# SERVICE BULLETIN

M-913A (Replaces Service Bulletin M-913)

## FINE-TUNING THE 1986 SOUND SYSTEM

Figure 1. P.I.S. Module

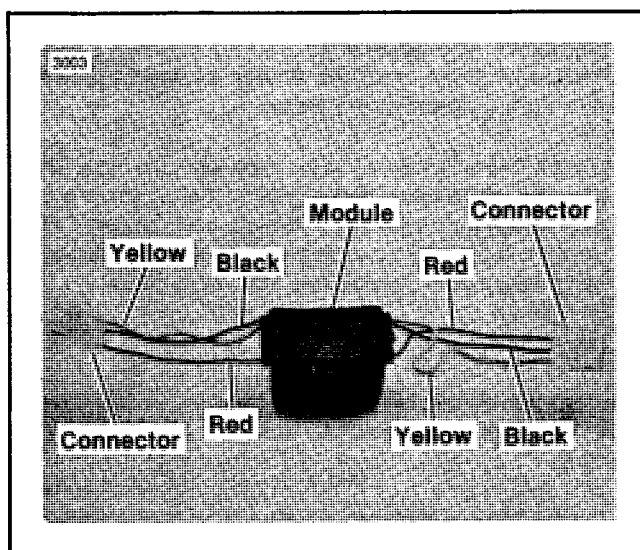
*See Figure 1. The P.I.S. circuit module is a black box. It can be identified by the color coded wires: red, black and yellow. All wire colors are solid.*

*The P.I.S. module is located in the fairing above the headlamp opening. There are two modules on the shelf. See Figure 1. The P.I.S. Module has solid red, black and yellow wires. The remaining module is the choke module.*

2. Check the wire colors to be sure you are removing the correct module. See Figure 1. Reach in through the headlamp opening. Unplug and discard the P.I.S. module. Connect the wiring harness by plugging the circuit connectors into each other.

2. Check the wire colors. See Figure 1. Unplug and discard the P.I.S. module. Connect the wiring harness by plugging the remaining circuit connectors into each other.
3. Install the instrument panel. Refer to the 1984 to 1986 FLT/FXR Service Manual.

2. Reach in through the headlamp opening and up on to the shelf. Pull the module loose and check the wire colors for the P.I.S. Circuit. Unplug and discard the P.I.S. module. Connect the wiring harness by plugging the two circuit connectors into each other.

Figure 2. Radio Caddy Mounting

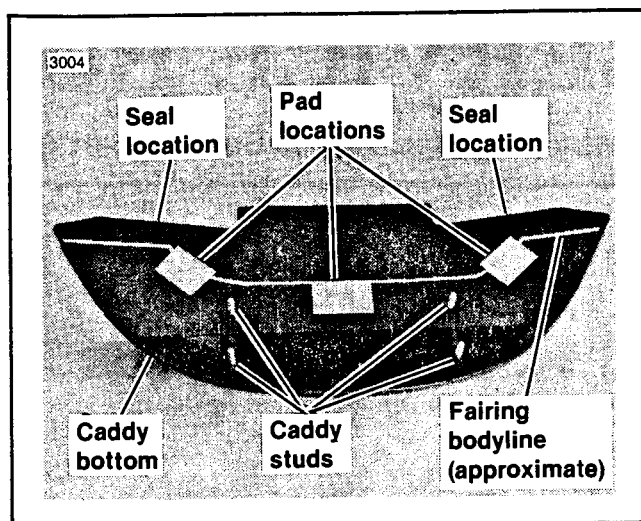
When the sound system gain is increased, the stereo speakers' back wave lifts the caddy speaker compartments off the fairing. This is a source of rattling, or speaker distortion, that may be heard by the rider. Pad and seal installation will eliminate the noise problems originating in the radio caddy.

Another change for this unit is the speednuts mounting the speakers. The speednuts retaining the speakers should be replaced with self-locking nuts.

1. Remove the windshield. Refer to the 1984 to 1986 FLT/FXR Service Manual.
2. Remove the headlamp housing. Refer to the 1984 to 1986 FLT/FXR Service Manual.
3. See Figure 2. Remove the nuts from the radio caddy studs through the headlamp opening.
4. Disconnect the circuit connectors and the radio antenna lead.

*Before removing the radio caddy reach under the caddy and scribe the outline of the fairing on the caddy bottom plate. See Figure 2. The fairing bodyline that you trace will assure proper placement of the pads.*

5. Lift the caddy off the fairing and turn it over.
6. See Figure 2. Place three radio caddy pads, Harley-Davidson part number 66104-84, on the bottom plate of the caddy. Place the U-shaped seal strips, Harley-Davidson part number 77060-86, directly under the speakers, on the caddy edge.

*Place the outer pads so they are centered over the fairing bodyline traced on the bottom of the caddy. Place the middle pad so it will be just behind the fairing bodyline when the caddy is in position. When the caddy pads and seals are properly positioned they will pre-load each compartment in the caddy, eliminating rattle.*
